HISTORIC ENGLAND

Message to the Council and other representors who attended the hearing session on sites H442 (land between Richmond Park and Sunnyside Avenues, Robertstown) and H198 (land south of Second Avenue, Liversedge)

Response by Historic England to Inspector's Questions, 27 March 2018

H198 – Second Avenue, Hightown, Liversedge

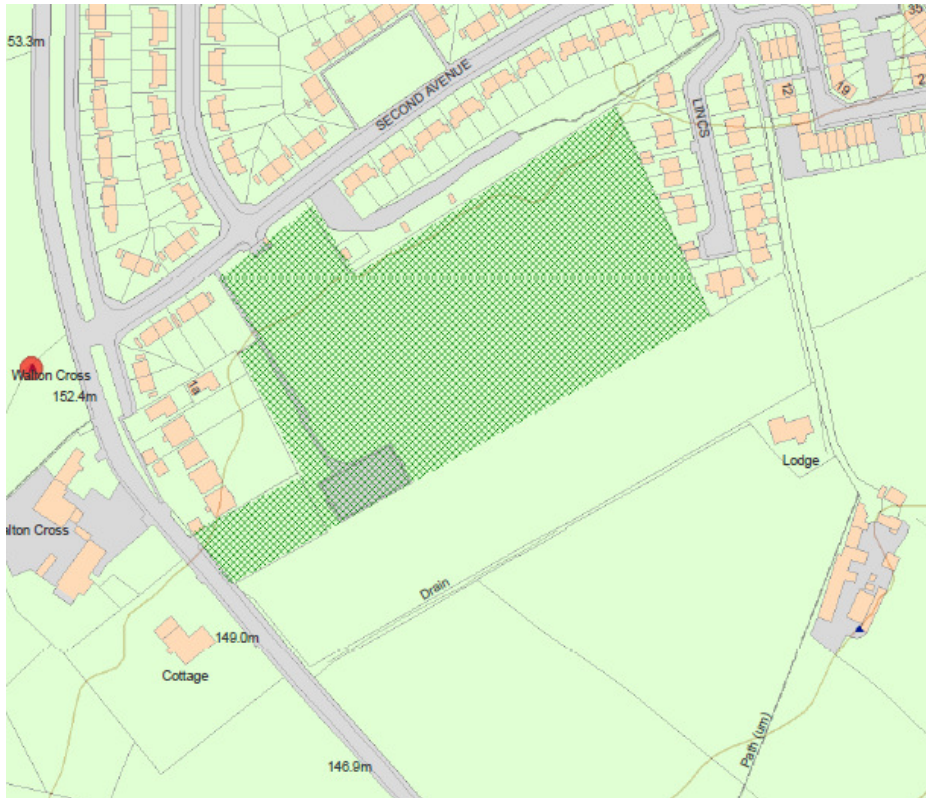
In order to make it clear precisely the extent of the developable area, it is suggested that Site H198 is amended as shown below:-

As we made clear in our Statement, it is the undeveloped nature of the southern part of this site which contributes to the rural setting of Thornbush Farm and its loss, no matter how well designed any buildings upon it, would urbanise the agricultural setting of this farm building and, therefore, harm its significance.

If the Council would still wish to continue with the extent of this allocation as proposed in the Submission Plan because it provides the ability to accommodate the open space requirements of this development, then the following development principle could be incorporated instead:-

"A 50 metre wide buffer shall be retained along the southern end of this site between Windy Bank Lane and Hawthorn Lodge to safeguard the setting of the Listed farm building"
